Subject: Closure Request Response, Fuel Leak Case No. RO0000124 (Global ID # T0600102093), Chevron #9-9708, 5910 MacArthur Boulevard, Oakland, 94605

Thank you for the recently submitted document entitled *Conceptual Site Model and Closure Request*; (RFC) dated March 29, 2013, which was prepared by Arcadis US, Inc. (Arcadis) for the subject site. With this submittal, Chevron requests case closure citing that current site conditions warrant case closure in accordance with the State Water Resources Control Board's (SWRCBs) Low Threat Underground Storage Tank Case Closure Policy (LTCP).

TECHNICAL COMMENTS

**Figures 2, 5, 6 and 7; *Monitoring Well Installation & Additional Soil Investigations*,
OTG Enviroengineering, Solutions, Inc, October 17, 2011**

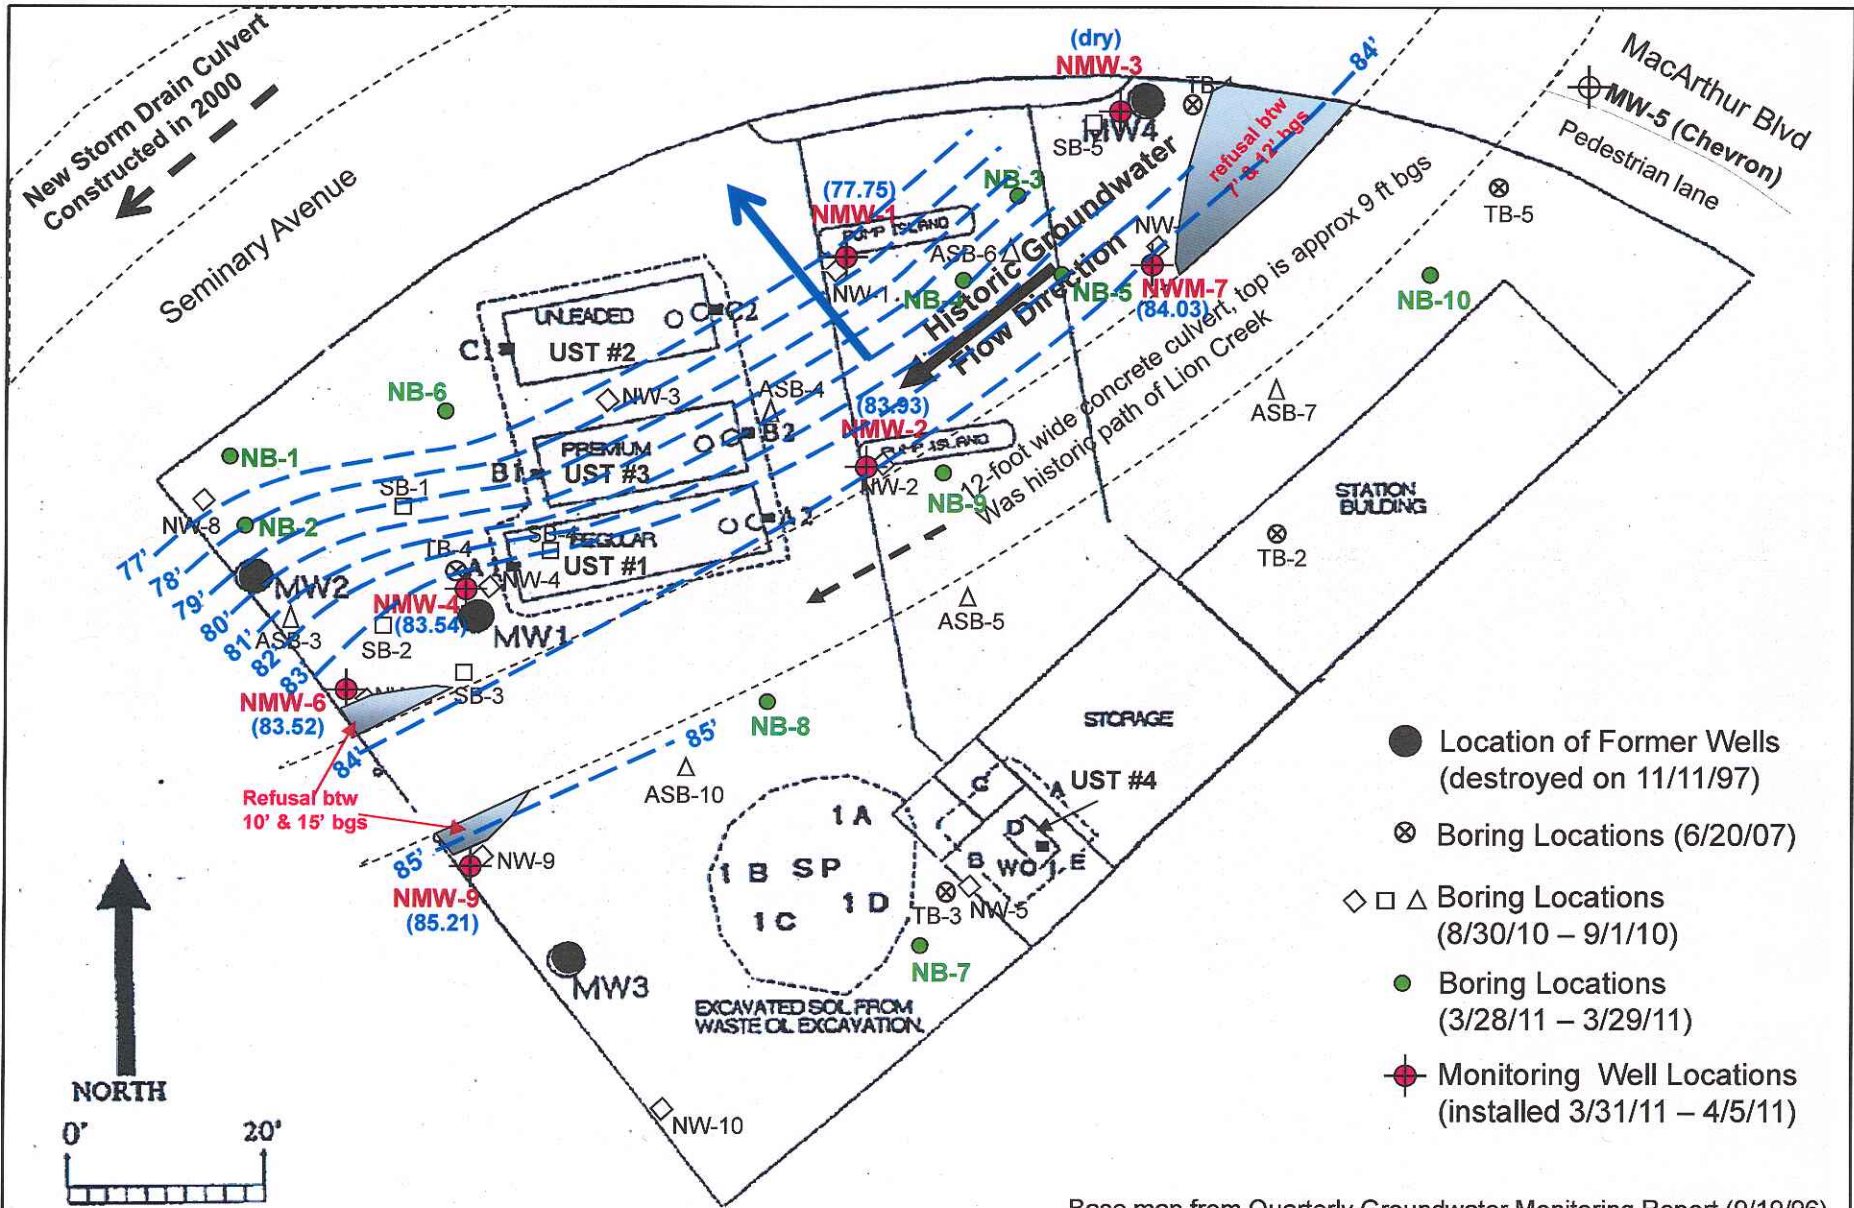
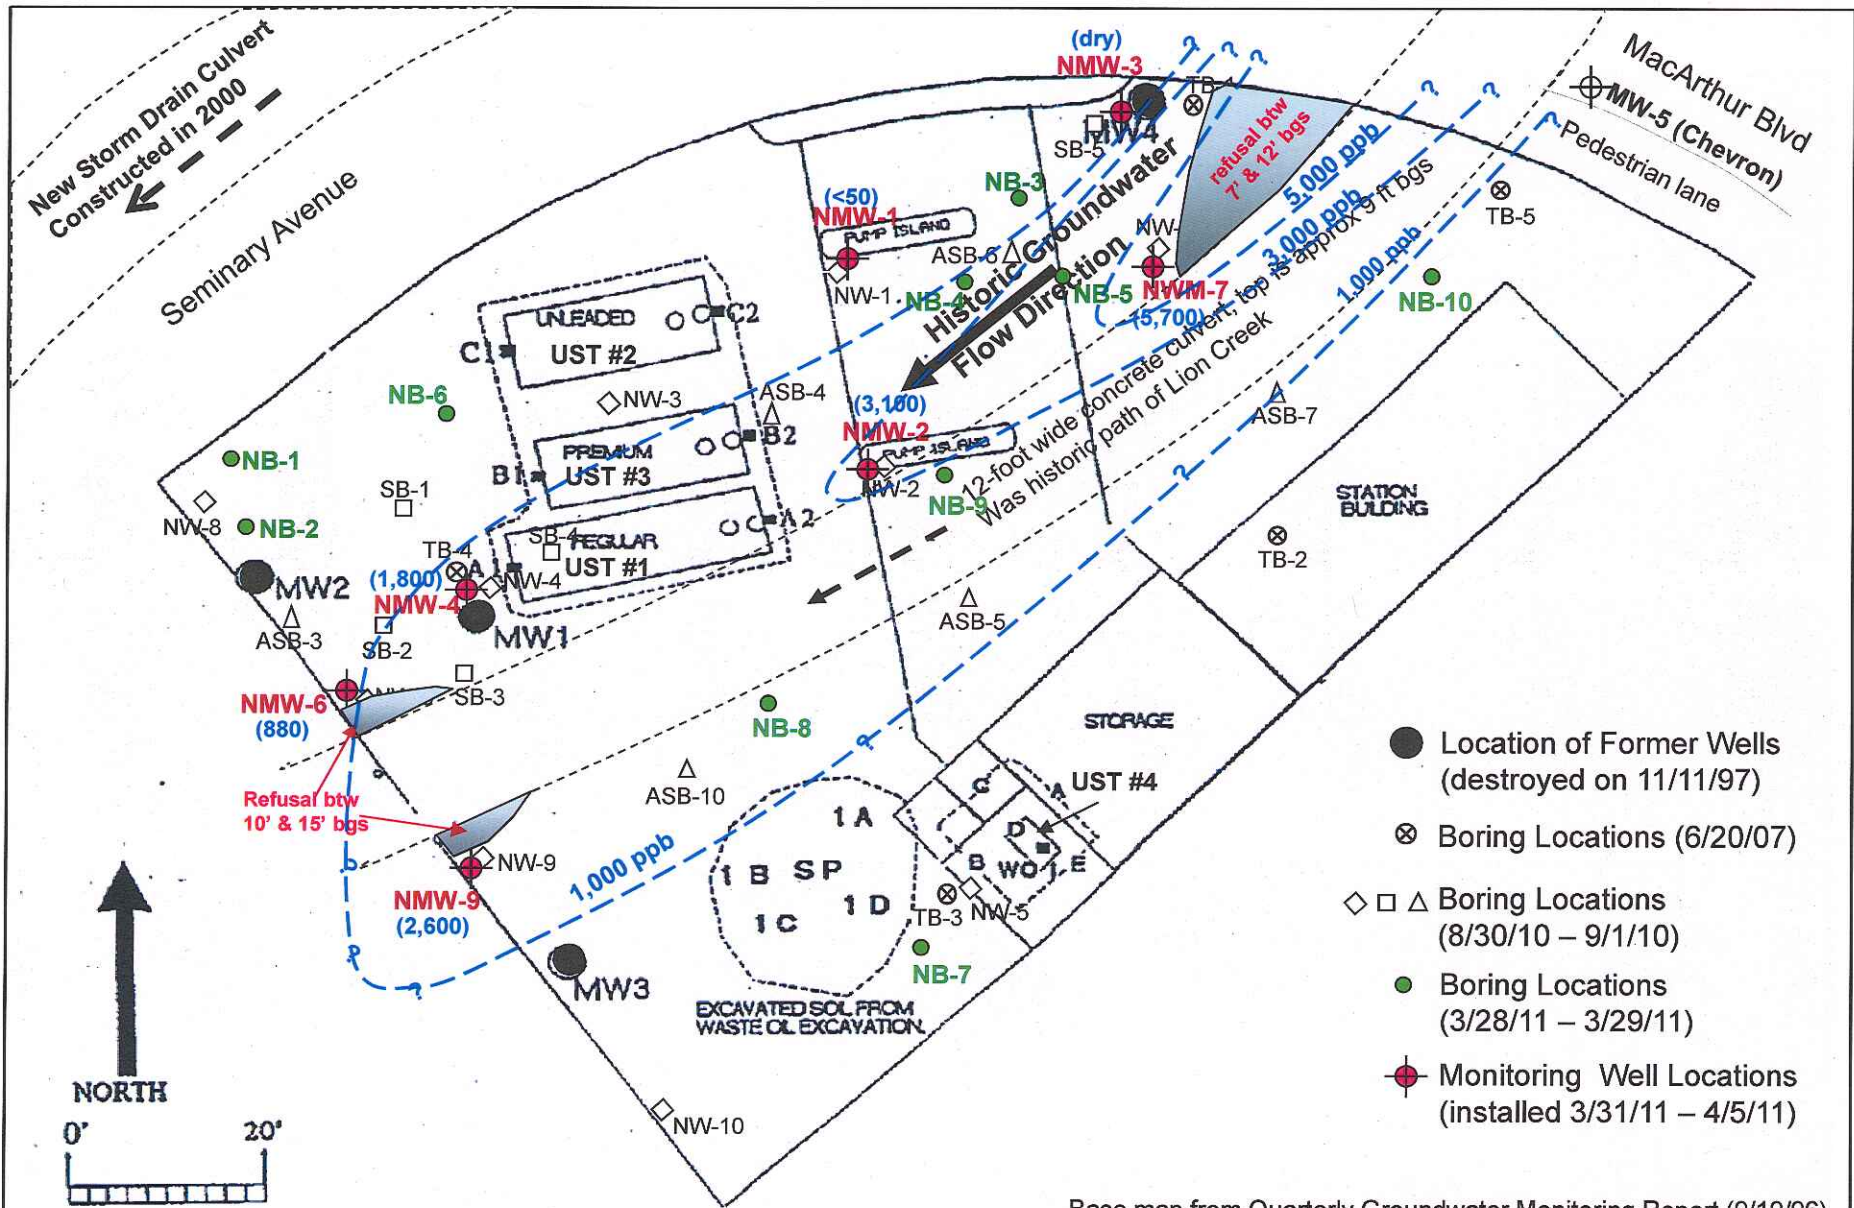
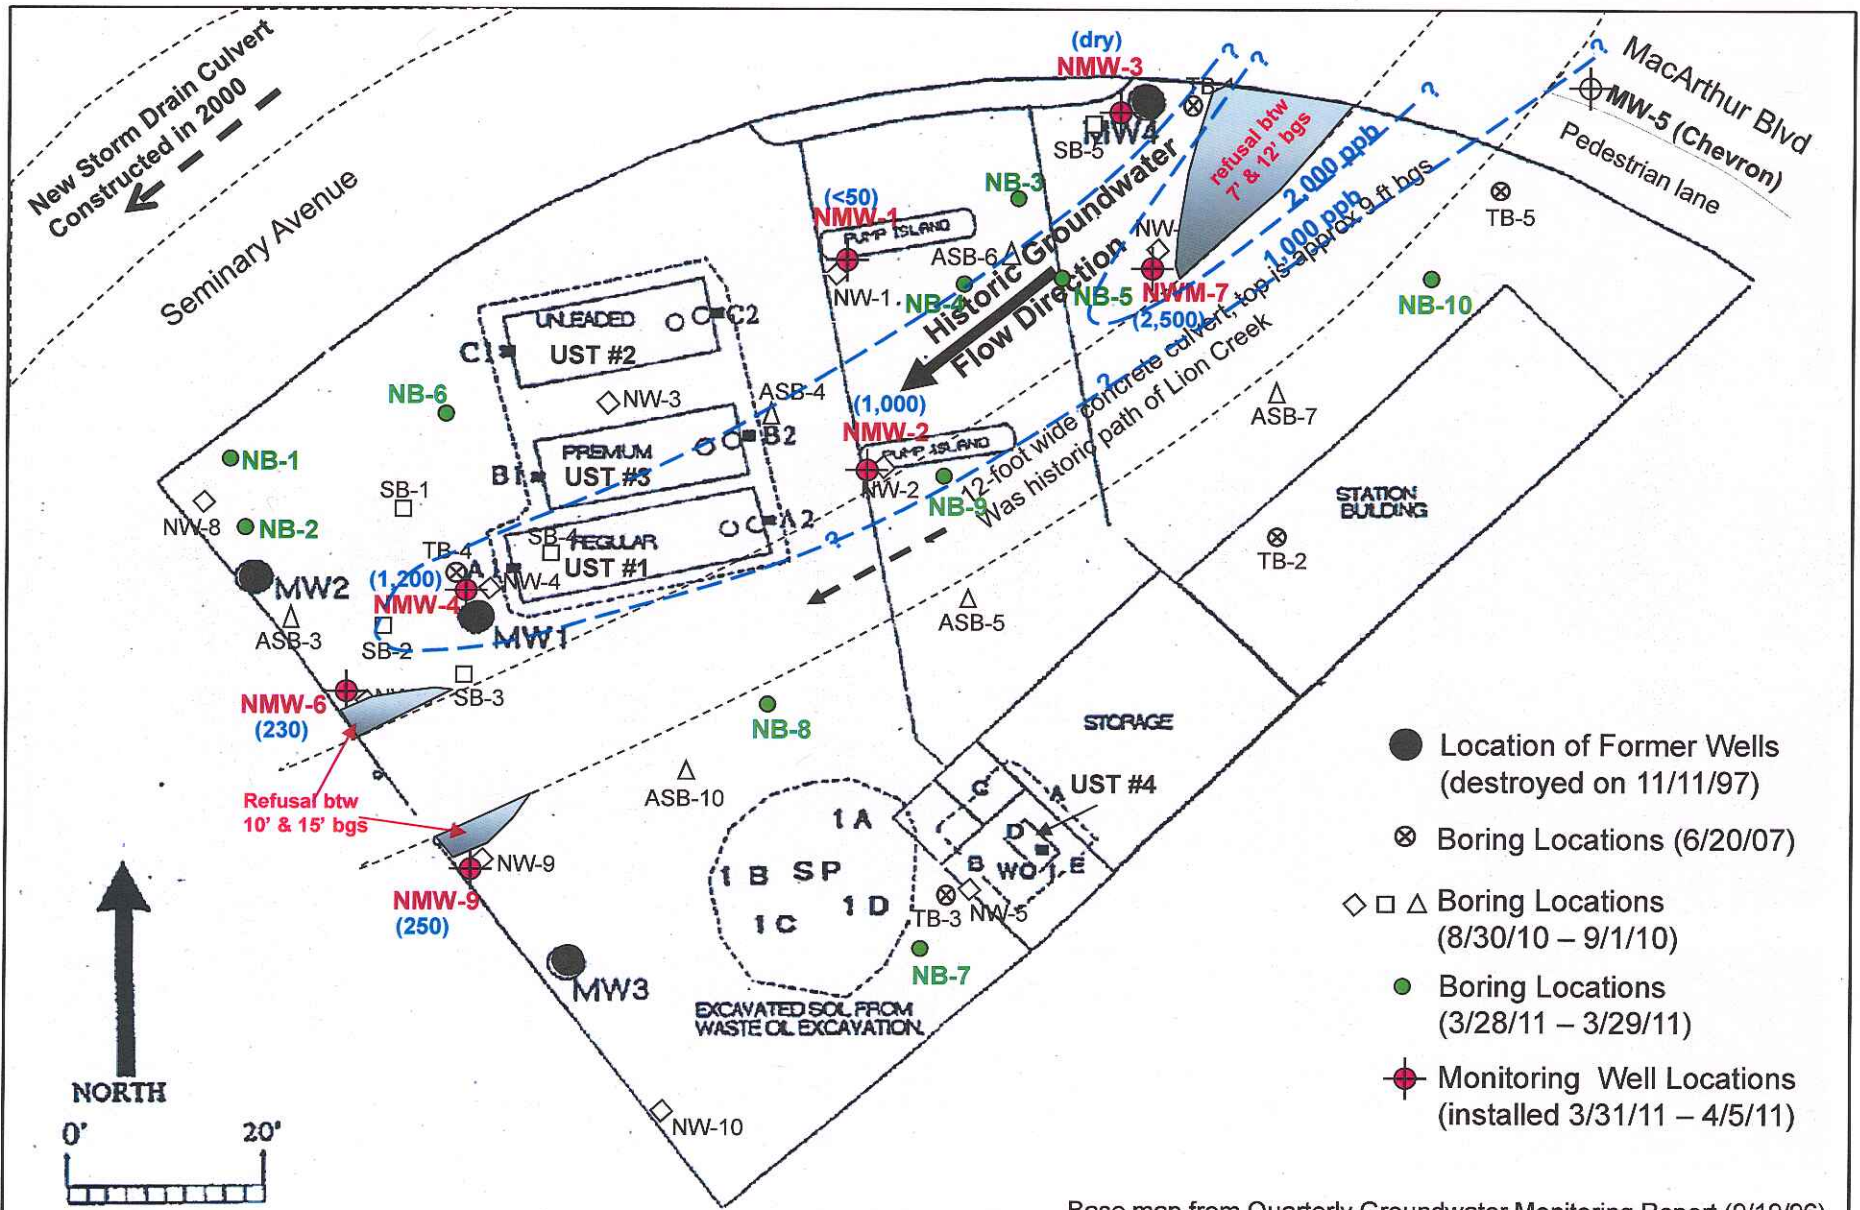
- b. **Lion Creek Channelization** - Review of the referenced soil and groundwater report for the Regal #404 / Huynh Property, located at 5901 MacArthur Boulevard indicates that the Lion Creek stream channel was abandoned in 2000 and was relocated to the north side of Seminary Avenue. The report clearly documents that the stream channel relocation directly affected groundwater flow at that site. The direction of groundwater flow changed from southwest and parallel to the former Lion Creek Stream Channel to westerly perpendicular to the stream channel. Review of documents associated with the Chevron site also shows a clear and direct change in groundwater flow direction. This is not accounted for in the Chevron SCM, and it is not clear how this may affect the groundwater plume. The report for the Regal #404 / Huynh Property also provides strong evidence for an upgradient component to hydrocarbon contamination at that site, similar to contamination emanating from the Chevron site (see Attachment B). This provides additional documentation that the plume extent is more extensive than suggested by site groundwater data. Additionally, the nature of the abandoned stream channel infill material (if any), and backfill material outside the former stream channel, remains uninvestigated beneath the site. Both areas of fill can affect groundwater flow.

- d. **Cross-Section Deficiencies** – While the location of the one of the Lion Creek Stream Channels is reflected on site figures, cross-sections do not depict the former Lion Creek Stream Channel beneath the site, nor do they depict the nature of the fill material inside (if any) or outside the former stream channel. As noted above, both areas of fill can affect groundwater flow and contaminant distribution in the vicinity.

- Groundwater well MW-2 is located upgradient of, and in proximity to, the abandoned Lion Creek Stream Channel and appears to have been the most downgradient well at the site for a number of years. It is not clear if groundwater at this well is representative of site groundwater concentrations or stream channel water concentrations. Groundwater well MW-4 is located onsite, but across the abandoned stream channel from the hydrocarbon releases. It is not clear if groundwater concentrations in this well are representative of downgradient groundwater concentrations at a location upgradient of the stream channel or if significant dilution by stream channel waters has occurred at the location of MW-4. This is strongly suggested by groundwater concentrations (highest concentrations at the upgradient edge) and distribution of the dissolved-phase plume at the Regal / Huynh Property site (ACEH Case Number RO0002959, Geotracker No. SLT19761201, 5901 MacArthur Blvd, Oakland). ACEH recognizes that the Regal / Huynh Property site likely also contributes to the groundwater plume beneath that site.

Consequently, please present a strategy in the Data Gap Investigation Work Plan described in Technical Comment 5 below to collect additional data to satisfy the additional characteristics of one of the five classes of sites listed in the policy.

Alternatively, please provide justification of why the site satisfies the media-specific criteria for groundwater in a focused SCM (described in Technical Comment 5) that assures that threats to existing and anticipated beneficial uses of groundwater and surface water have been mitigated or are de minimis.
